## **Bluetooth Chip**

Storage area of software will be changed from external Flash to internal mask ROM.

## Present BT module

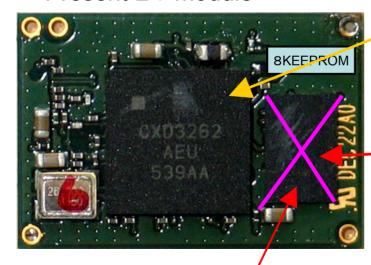
Regarding RF parts, there's no modification because the silicon is the same.

And there's also no modification of Bluetooth identifier.

Delete this Flash ROM And install **EEPROM** as alternative
